RE: TPDES Permit No. WQ0014716001

I am writing to not only request a 'Contested Case Hearing' but also to request a 'Reconsideration of the Executive Director's Decision'. I am an adjoining property owner to the proposed sewer plant discharge. I have read the "Executive Director's Response to Public Comment" and I have found it most disturbing not only to the environment, but also to the residents of Swan Point. I will address the E.D.'s responses to our concern's below:

PHOTOGRAPHS AND
OTHER SUPPORTING
DATA

Swan Point Photographs

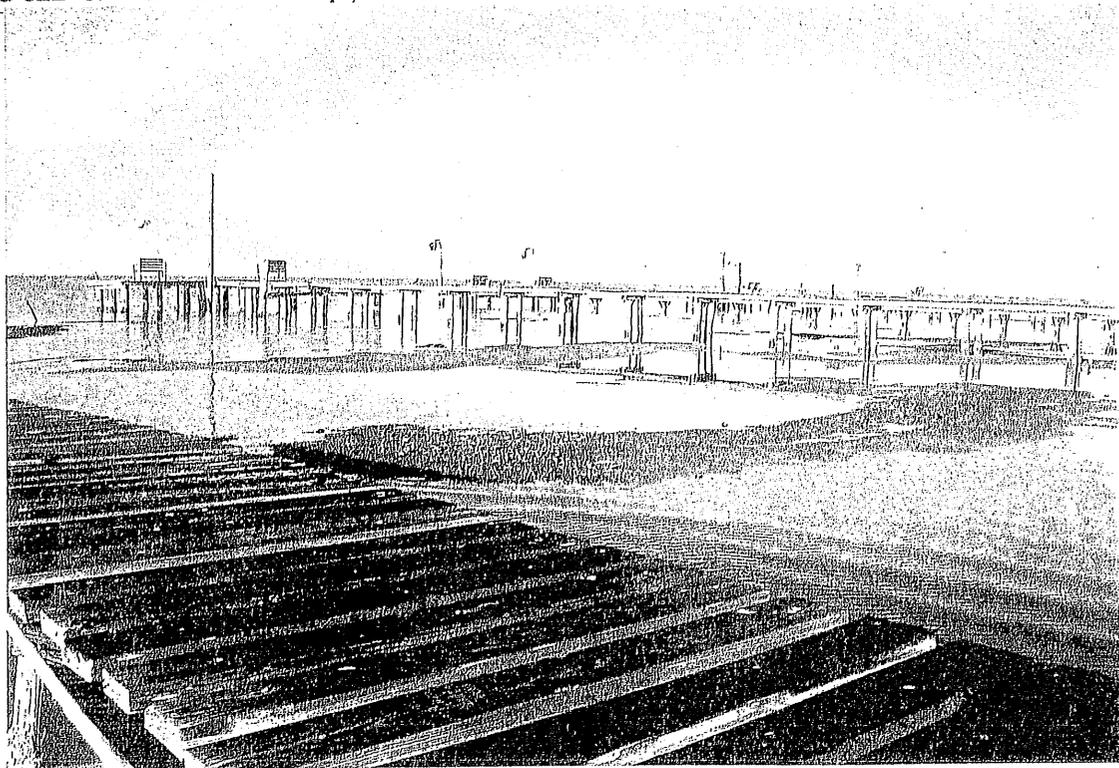
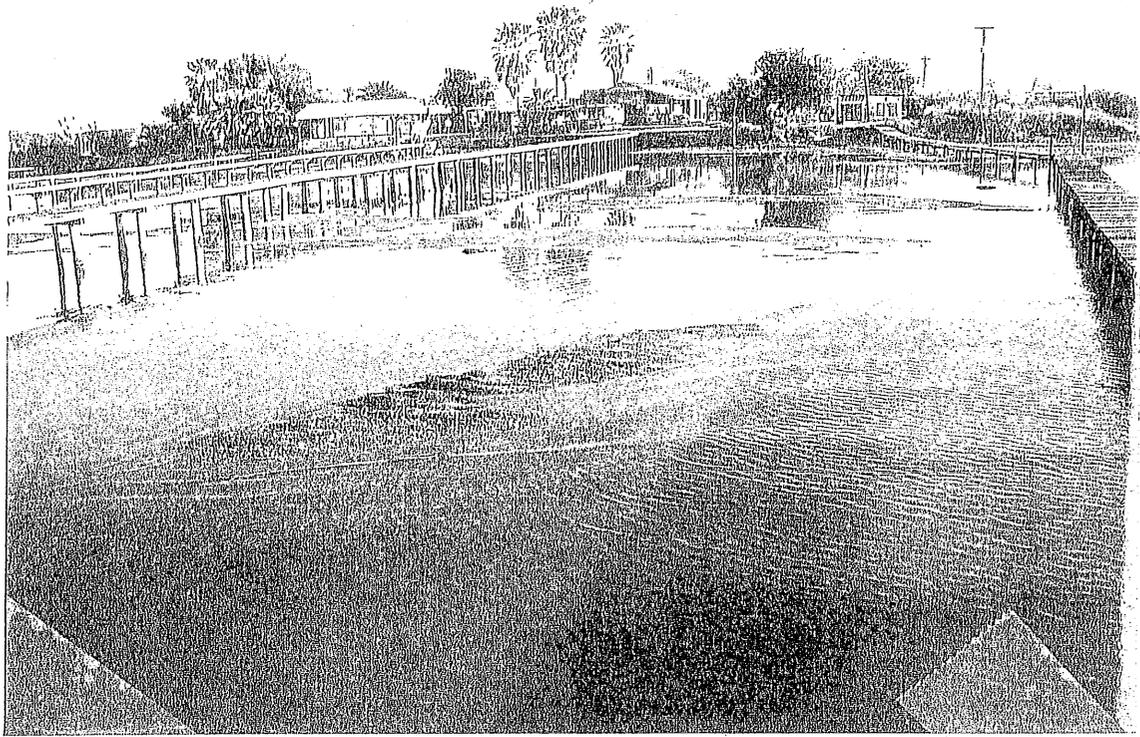
View from shoreline behind my house showing shallow water depth and nothing but mud to over 100' from shoreline.

View from my pier looking seaward at 150' from shoreline.

Swan Point Photographs

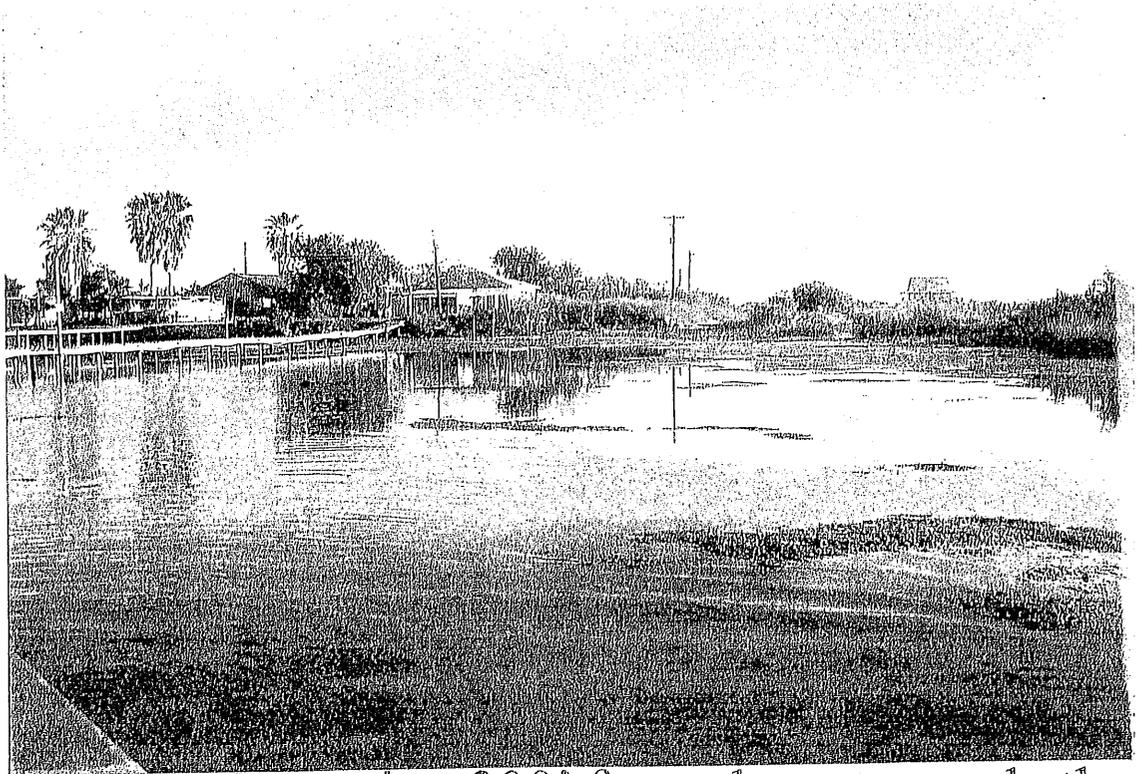
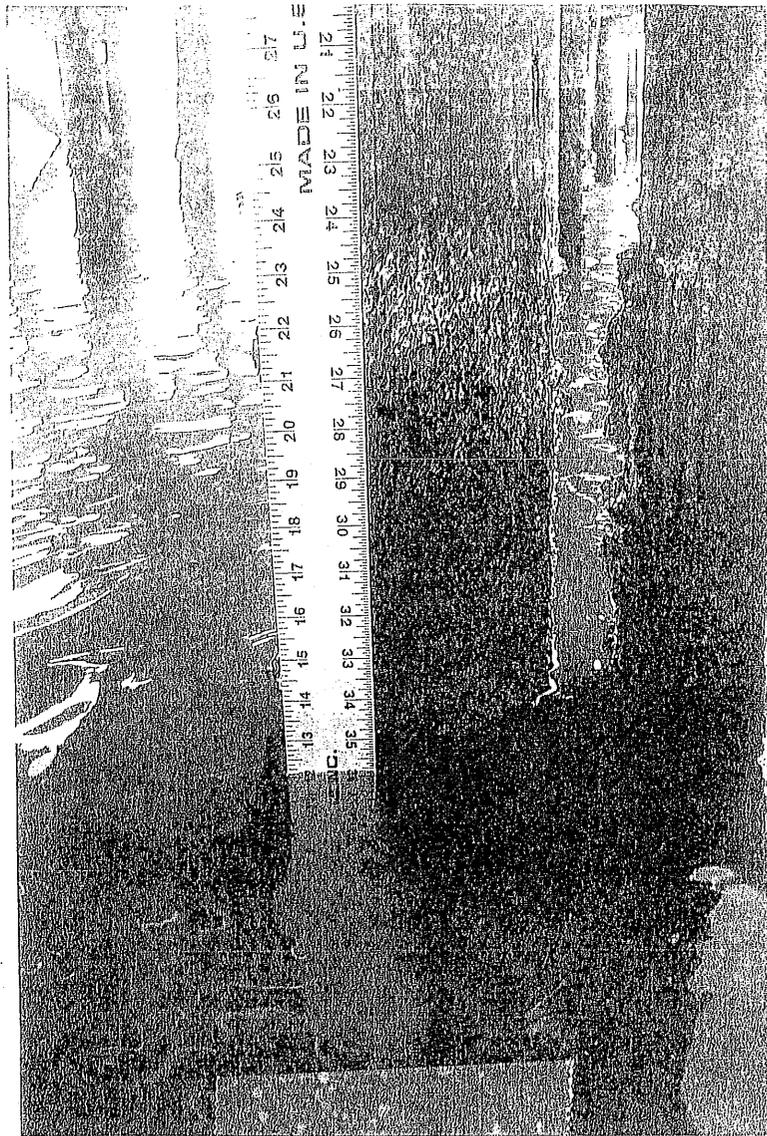
View from the end of my pier (300' out) looking toward shore.

View from kayak moving 300' from shore towards the Falcon Point Ranch sewer outflow. Shallow mud and still water.

Falcon Point Photographs

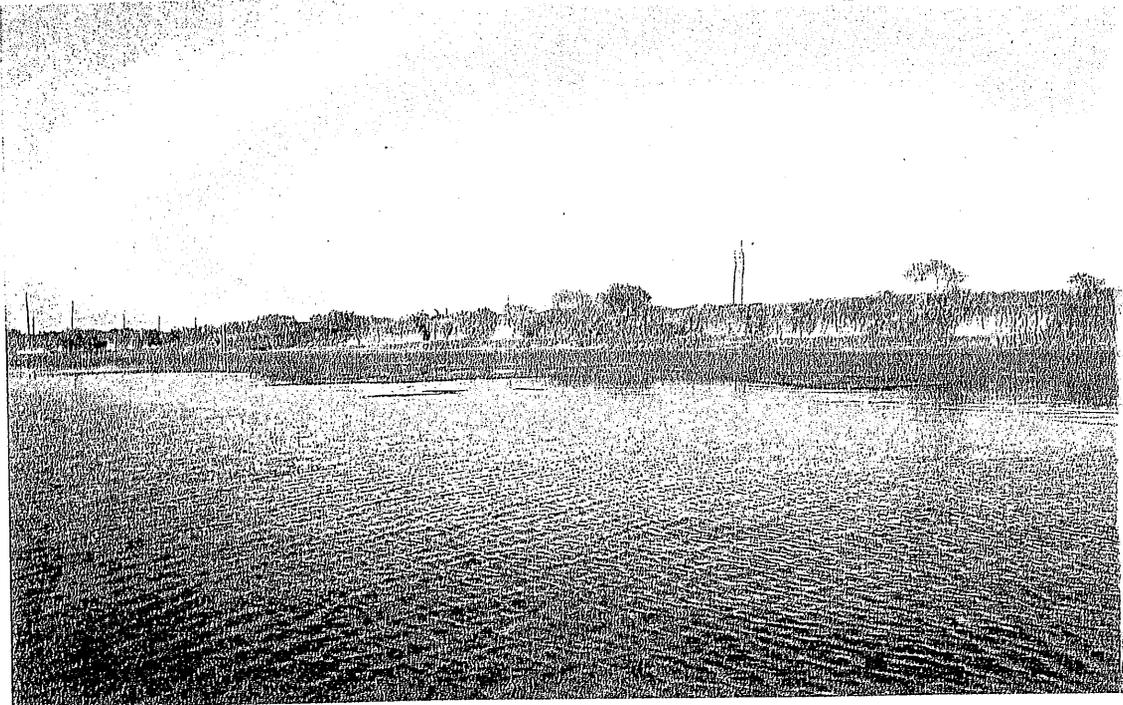
Moving towards the Falcon Point Ranch sewer ditch outflow site, it is evident the shoreline is void of any water for 100+ feet

...and the water 300'+ out is very shallow and no mixing with 'normal' tidal action is evident....a stagnant mess in the making?

Falcon Point Photographs

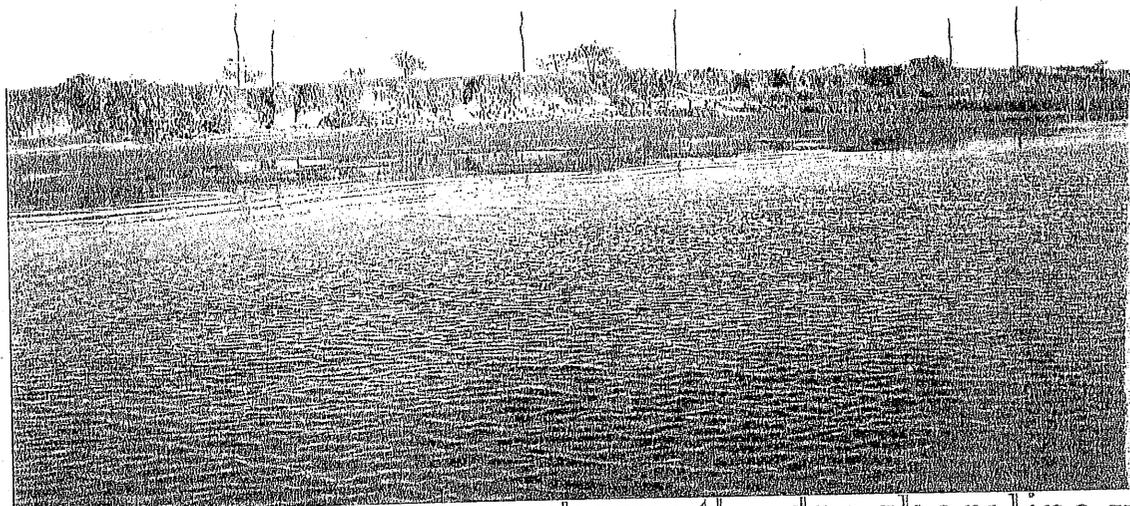
A little closer view of the area shows the dry shoreline where the outflow will be located. Where is the effluent going to dissipate?

Falcon Point Photographs

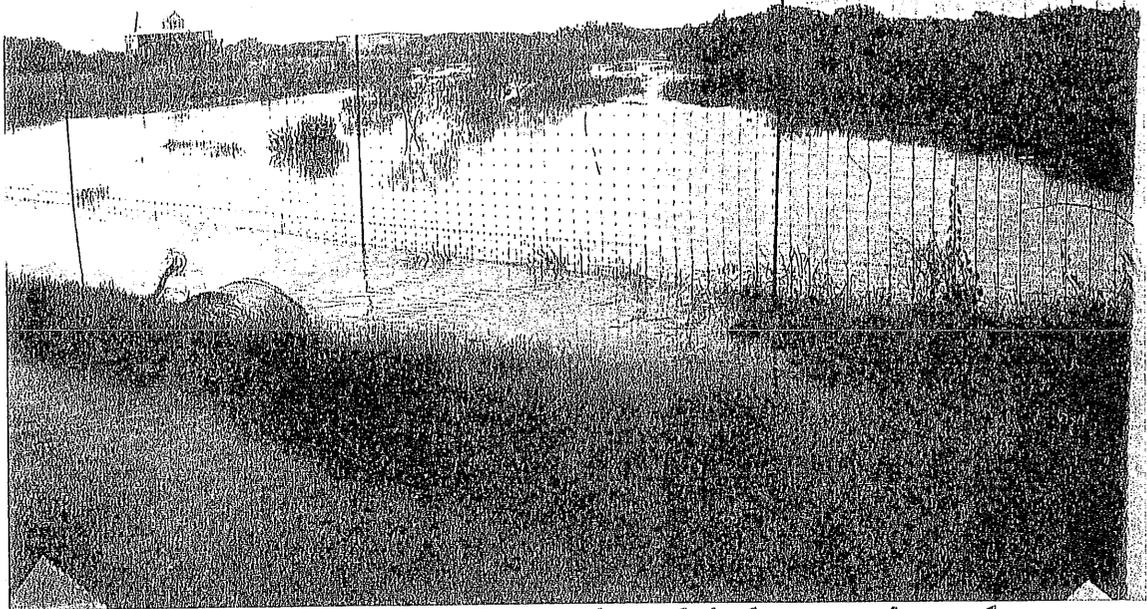
A view of the 'draw' on the Ranch which carries the wastewater to the bay. This series of photos were after a 'normal' rain.

The deluge comes under the road, into a ditch on my property....

Falcon Point Photographs

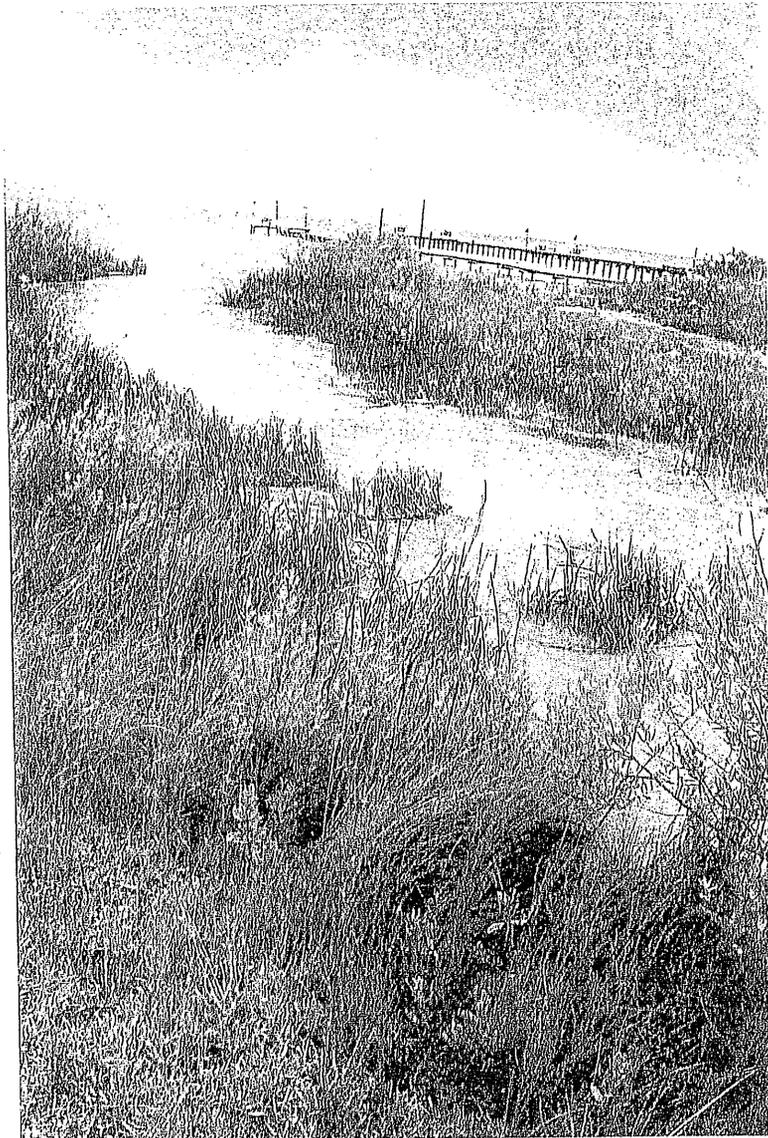
.....through the ditch on my property.....and into San Antonio Bay!

Falcon Point Photographs

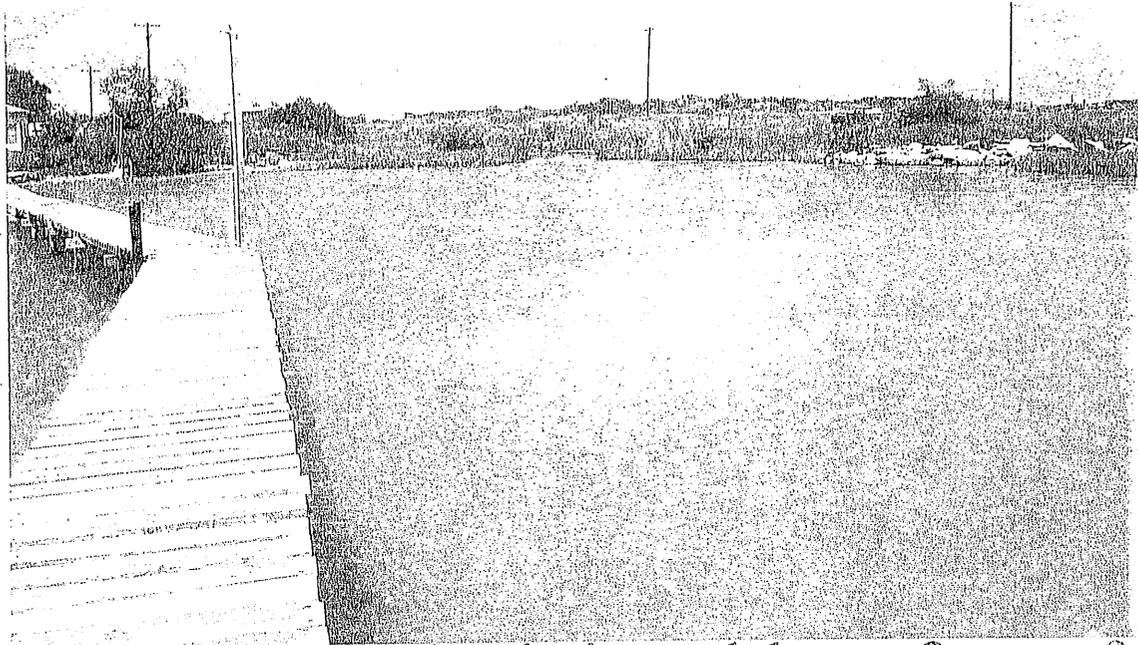
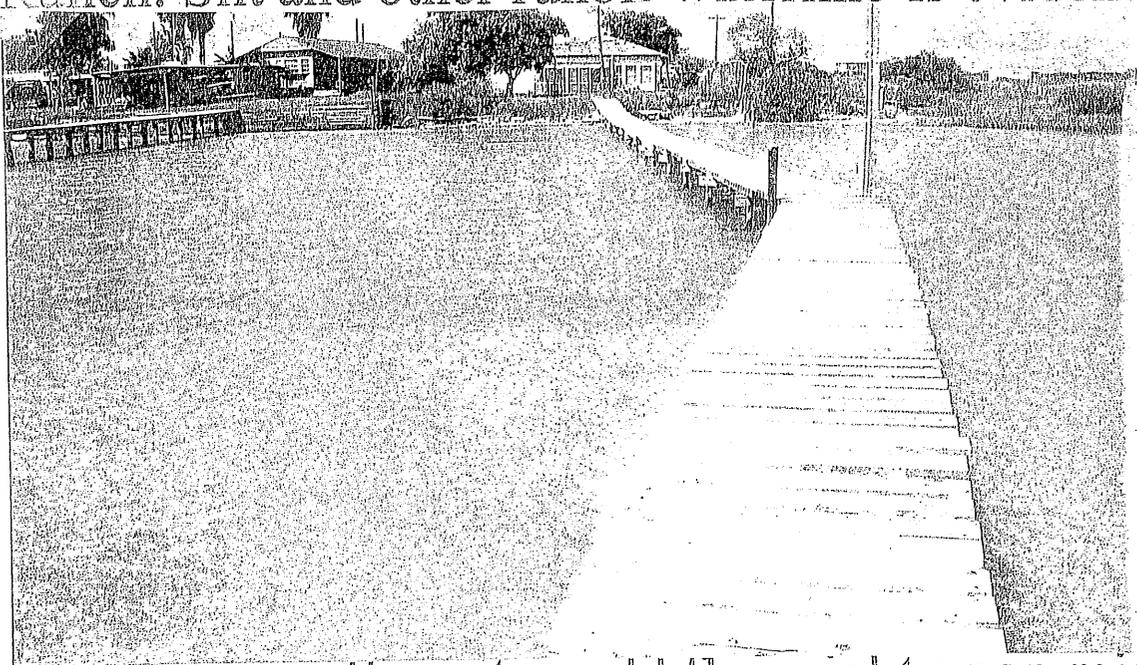
Photos taken from my pier during a deluge of water from the Ranch. Silt and other runoff waterline is evident.

If this was sewer overflow, it would flow right upon mine & my neighbors' property. Silt buildup in the bay from Ranch runoff continues to be a problem as well.

TEXAS GENERAL LAND
OFFICE PRODUCED MAP
OF SEAGRASSES AND
RESOURCE
MANAGEMENT CODES
FOR THE
SAN ANTONIO BAY AREA

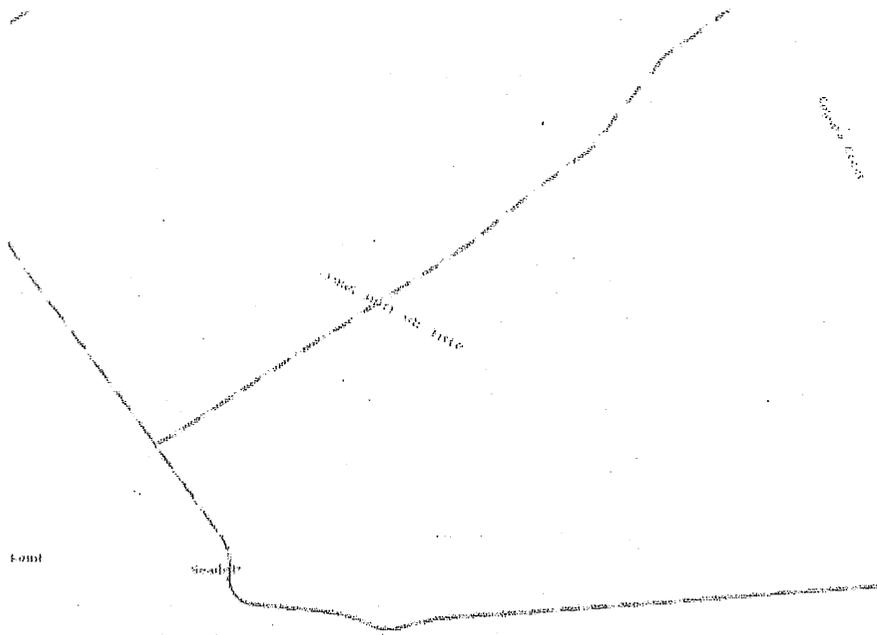
no negative impacts to sea grass: will occur." The enclosed color (red) map of the area (published by the Texas General Land Office) clearly shows the abundance of sea grasses in the area that will be affected. And, your Response 11 opens the door for future expanding and upgrading of the facilities. I can only guess how much they will want to dump into the bay in their next sewage application.

I would like to call your attention to the attached 'Resource Management Codes' recommended by the Texas General Land Office for the area surrounding the proposed outflow ditch. I have highlighted a few of the more relevant recommendations as they apply to this issue.
